**DEPARTMENT OF DEVELOPMENT SERVICES – PLANNING DIVISION**  
**REPORT: Inland Wetlands & Watercourses Permit, 2 Maxim Rd.**  
for consideration September 22, 2020

**STAFF REPORT**

**PROJECT:** Bridge Construction at  
2 Maxim Rd.  
PARCEL ID: 315-693-002  
ENERGOV ID: P&Z-COMM-2020-0156

- HAND POWER TOOL SURFACE PREPARATION WITH SOLVENT
- APPLY EPOXY BASED COAT, SUCH AS SHERWIN WILLIAMS "EPOXY MASTIC ALUMINUM II" OR EQUAL
- APPLY TOP COAT, SUCH AS SHERWIN WILLIAMS "ACROLON 218 HS - ACRYLIC POLYURETHANE" OR EQUAL

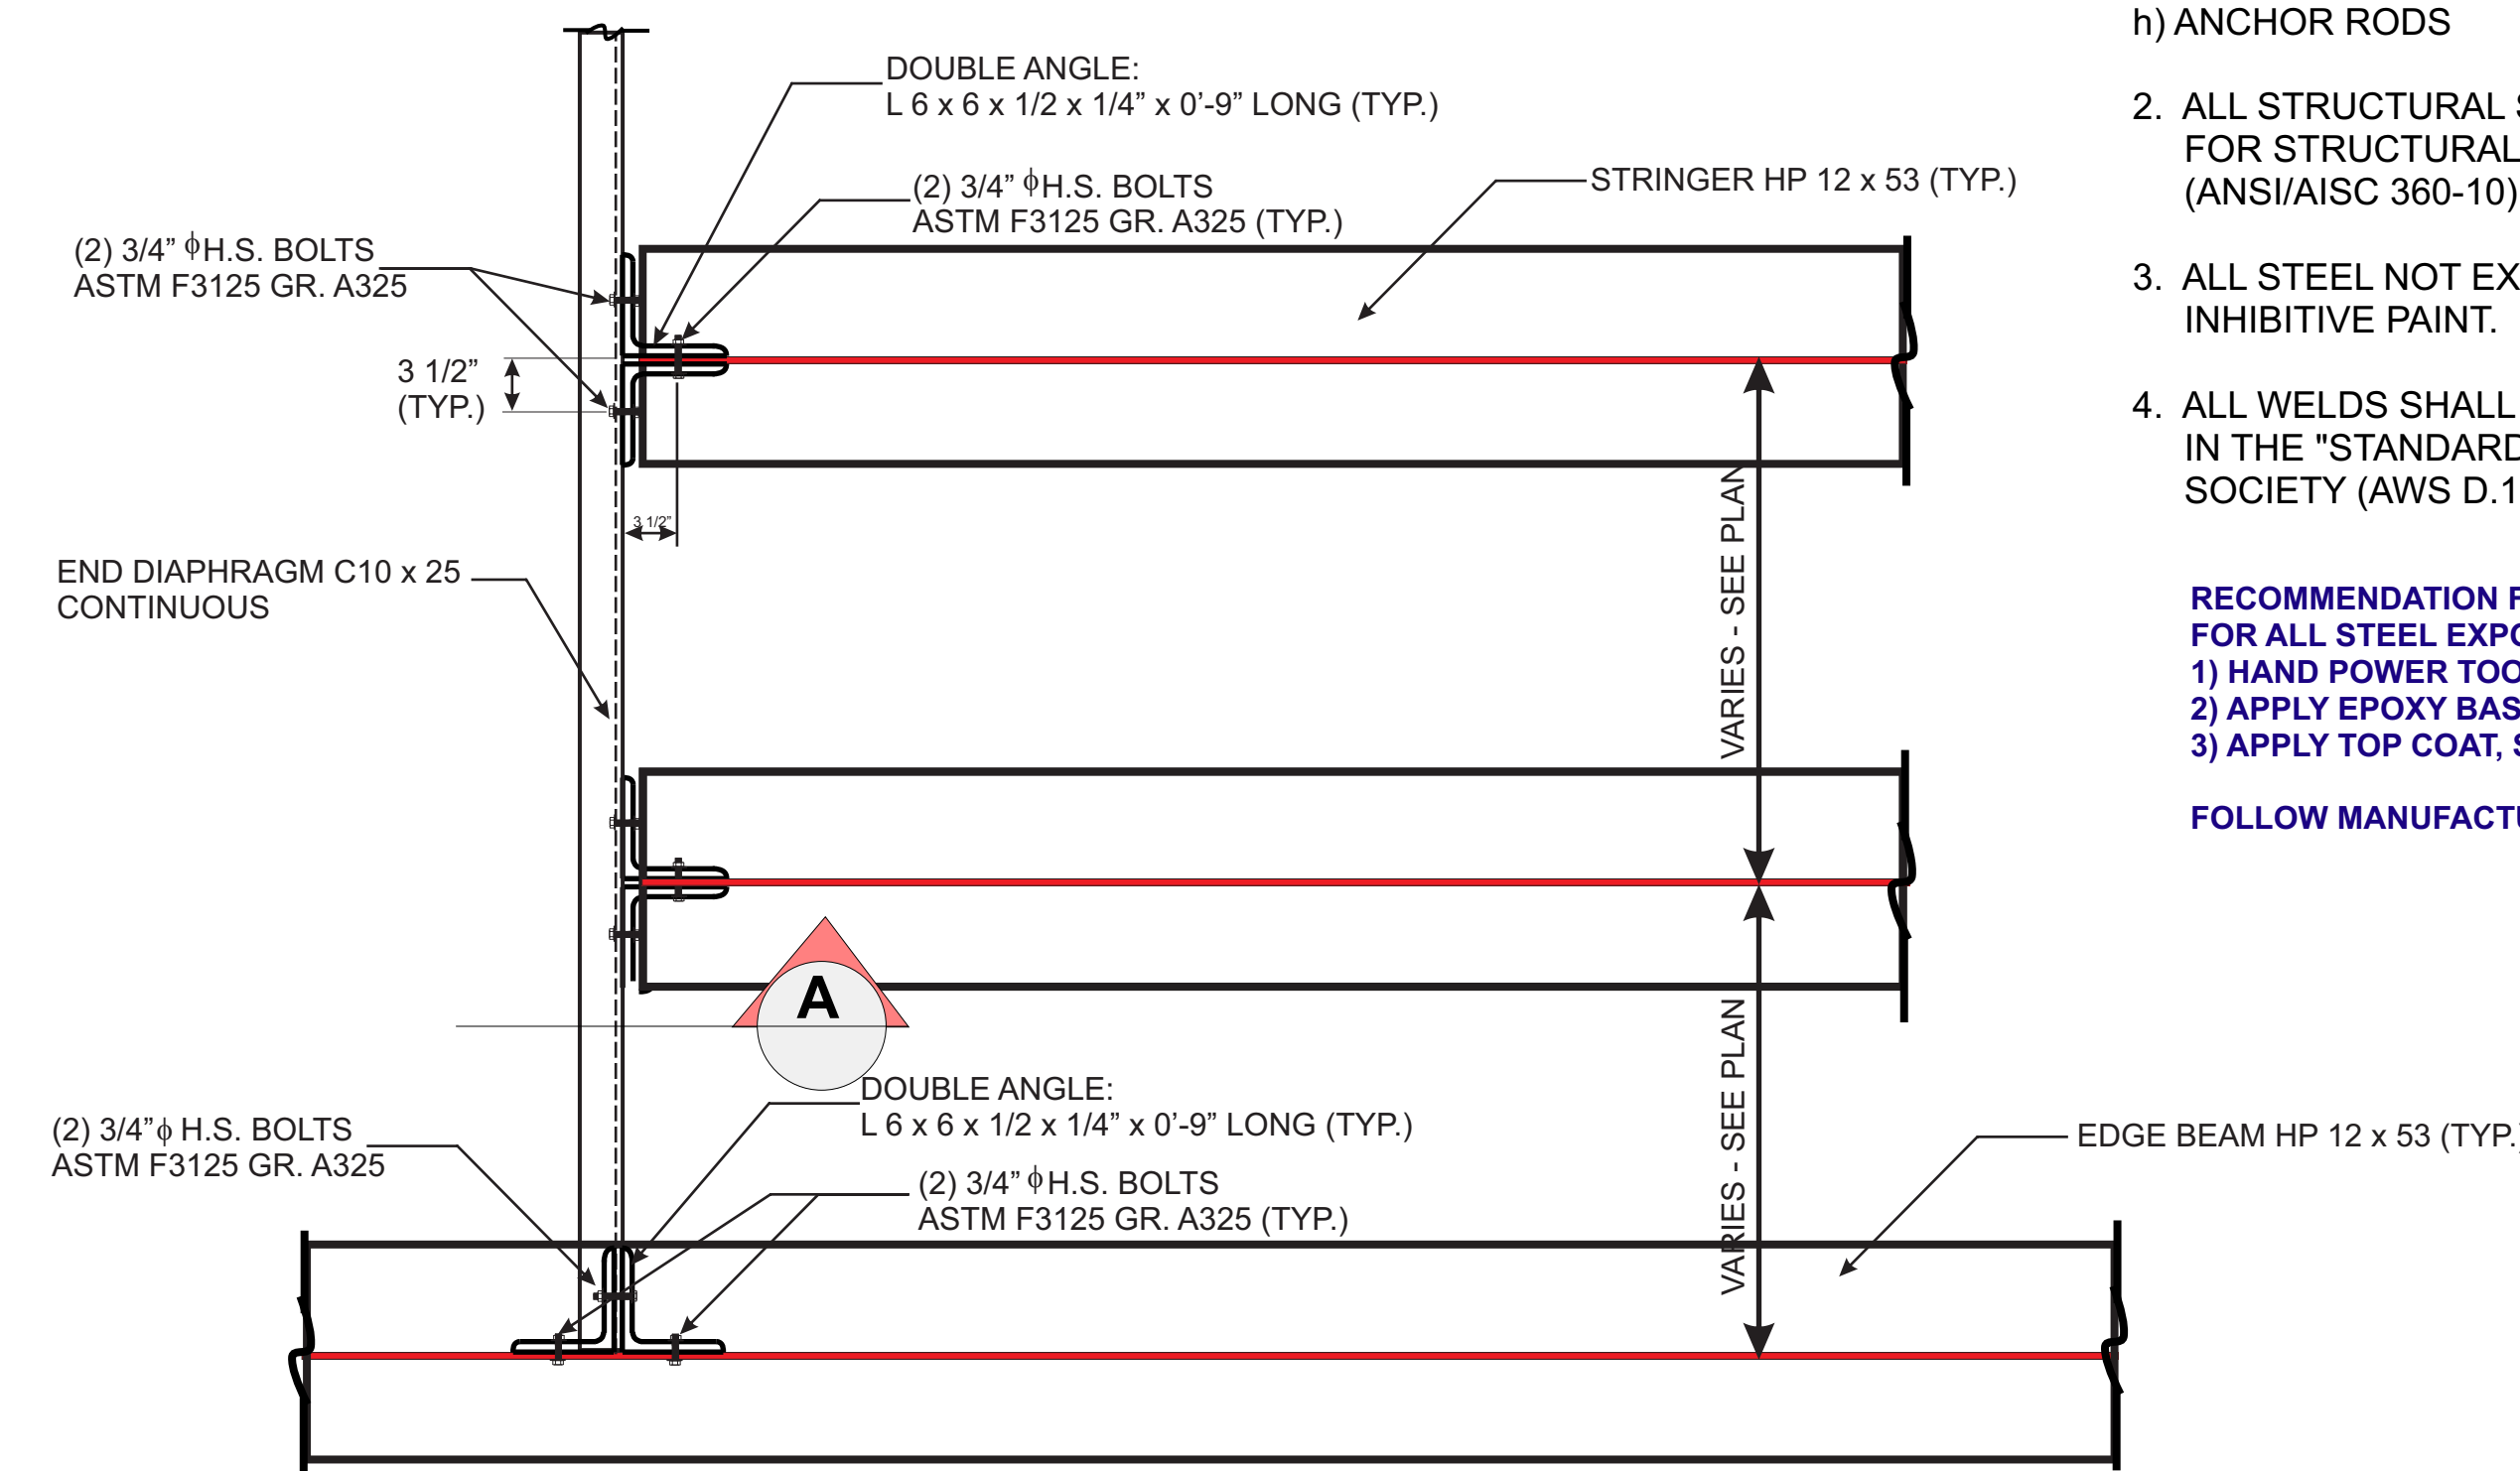
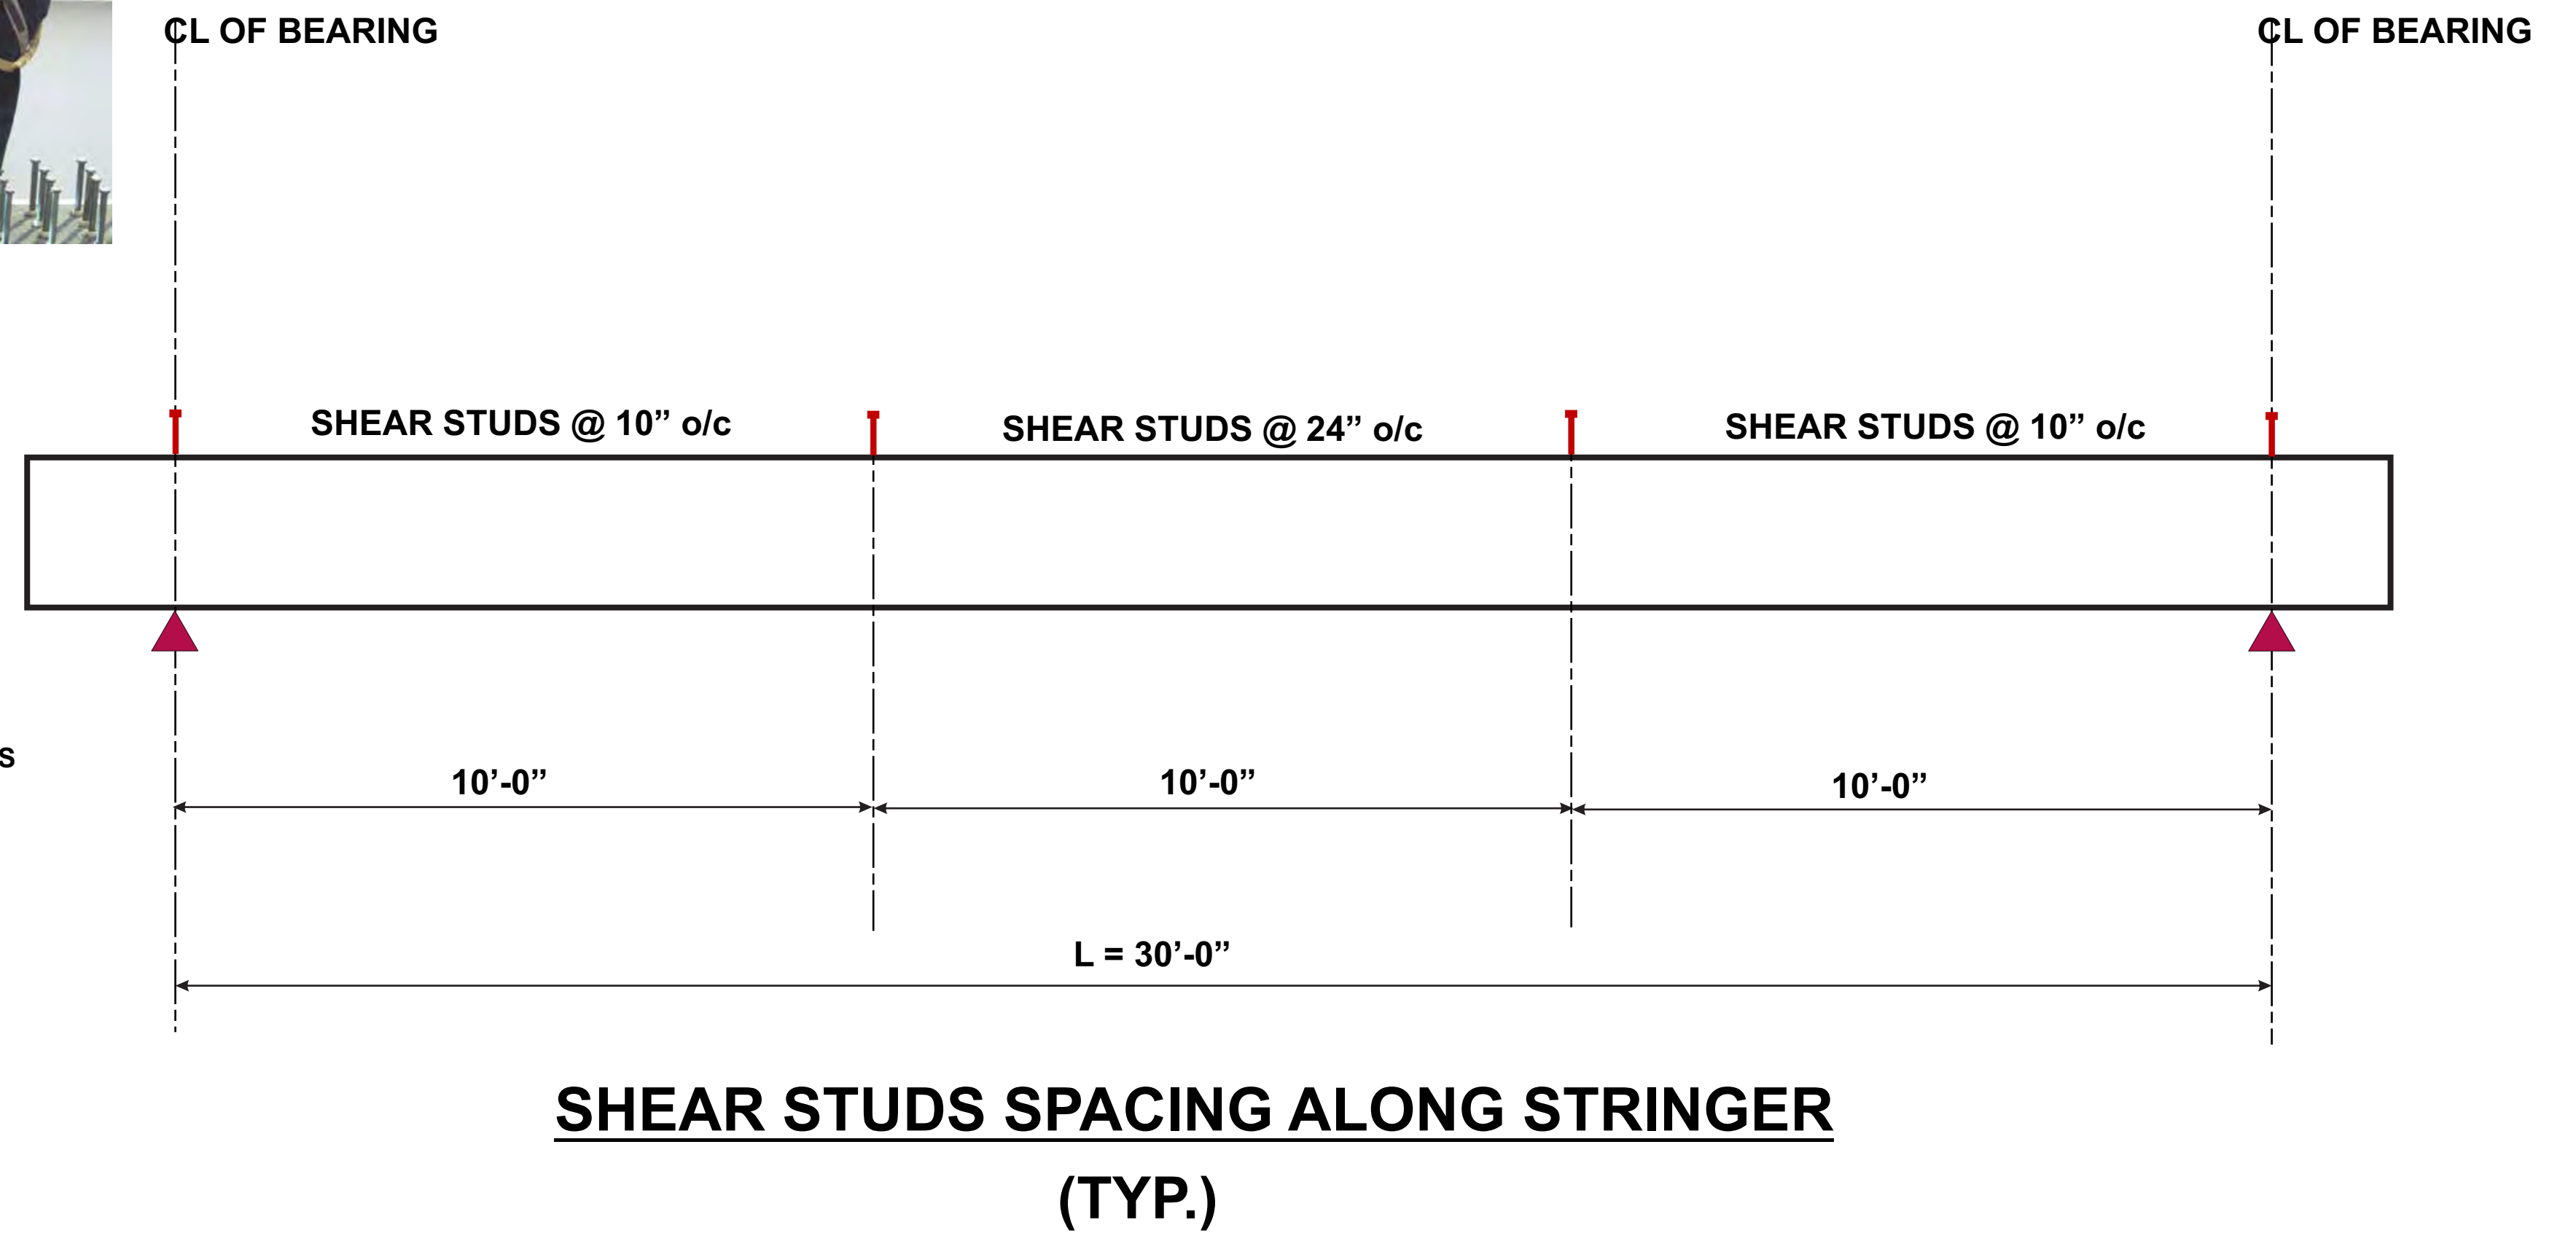
- Structural Design Drawing of the bridge, certified by a structural engineer, indicating design will withstand the loads of the intended users (dump trucks, heavy equipment, etc.)
  - Include a cross-section at the wetlands/watercourse crossing.

- Revised Site Plan to include the following:
  - Modifications to proposed bridge, designed/certified by a structural engineer

The set stringers will require the top flange to be laterally braced at midspan to prevent lateral buckling and meet the bending strength requirement. The lateral bracing would be accomplished by welding the boundary 6" deep channel around the concrete deck to the stringers.

At each abutment the stringers should be ties together (cross frame / diaphragm) to prevent axial rotation (twisting) of the stringers on the bearing support.

The bridge is existing and has been inspected by a Connecticut licensed structural engineer. He has completed a 14 page report and a two page plan showing the bridge to be structurally sound and having the load capacity to support large heavy truck traffic. The bridge will need a concrete deck which will be poured in place to be complete. We will obtain a building permit to pour the concrete deck prior to any work being started.

See Structural Engineers Plan
